P5027A-03A-S

Safety Service Note

P5027A Keysight Streamline USB Vector Network Analyzer

“POTENTIAL BURN INJURY (HIGH TEMPERATURE) HAZARD”

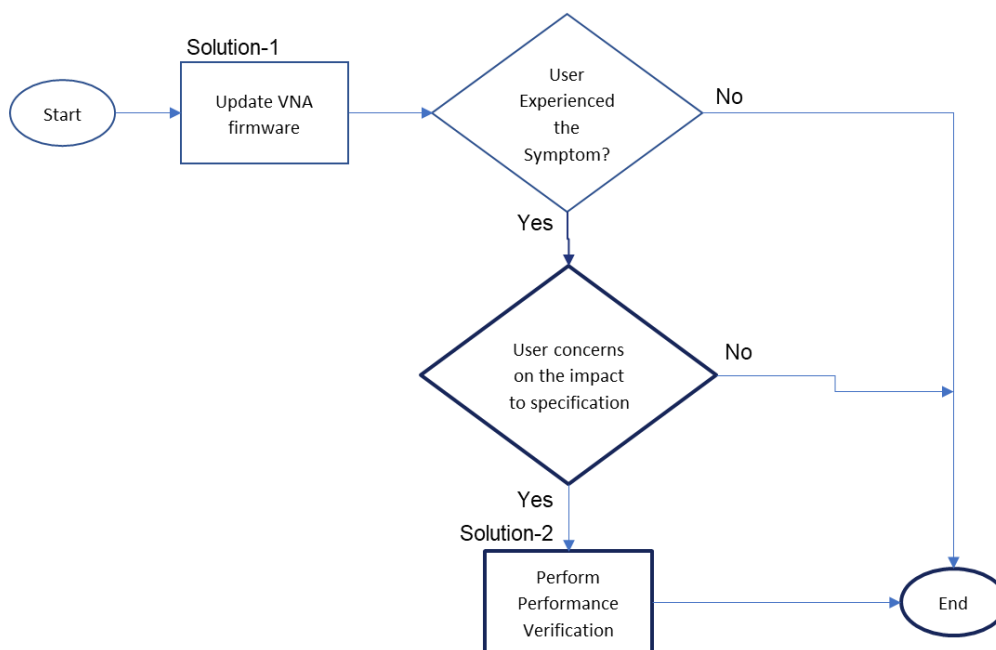
VNA fails to start with the following symptoms.

1. LED indicator (below circle) turns red.
2. cooling fan does not work
3. If user leaves the VNA with this LED indicator red without turning off power switch, it continues to overheat and becomes too hot.

Solution-1: Update VNA firmware by user

Solution-2: Perform Performance Verification by Keysight

1. **Install the latest VNA firmware Rev. A.15.55.14 or newer** on users' controller PC(s).
The latest firmware enhanced the thermal fan control mechanism.
2. Once the latest firmware is installed, proceed with the restart of both **controller PC** and **VNA**.
3. Launch the VNA firmware. Ensure VNA powers up and launches into firmware correctly after firmware update is done.
